Staff Report
City of Richmond, Virginia

Commission of Architectural Review

| 7. COA-112855-2022 | Final Review | Meeting Date: 6/28/2022 |
| Project Description | Construct a rear addition onto 3 attached dwellings. | |

Figure 4. Original rear porch design at attached 2509 E. Franklin Street. Simple design with slim square posts and Richmond Rail.

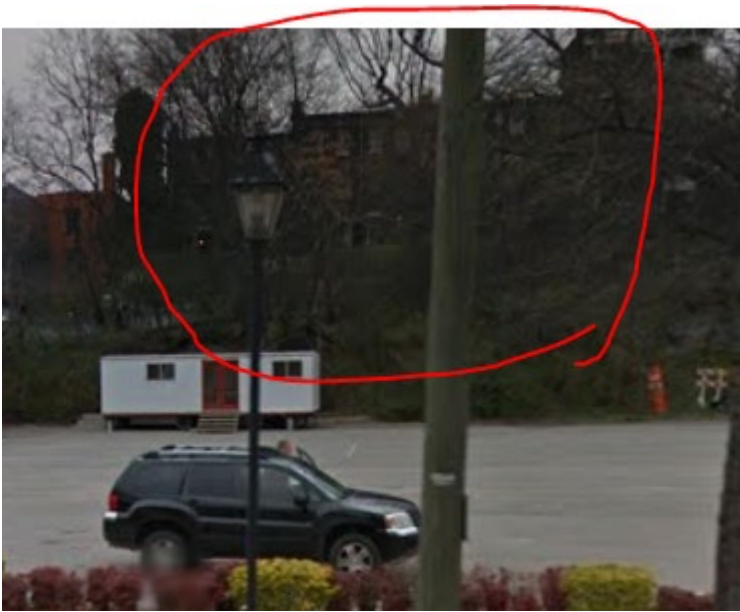
| Standards for New Construction, Materials & Colors, pg. 47 | <p><i>2. Materials used in new residential construction should be visually compatible with original materials used throughout the district.</i></p> <p><i>3. Paint colors for new additions should complement the historically</i></p> | <p>The proposed rear additions will feature horizontal, hardiplank, lap siding, parged masonry foundation, aluminum clad wood windows, aluminum gutter and downspouts, TPO Membrane roofing, solid wood doors, hardi trim, wooden decking.</p> <p>Gutters and downspouts will be aluminum. <u>Staff recommends that either half round or box getters be utilized on the rear additions, final specifications submitted to staff for review and approval.</u></p> <p>From the drawings submitted to staff, it appears that the new rear covered decks will feature Richmond Rail. <u>Staff recommends that the rear decks feature Richmond Rail and a finished appearance with no exposed hardware or nailed-up pickets.</u></p> |
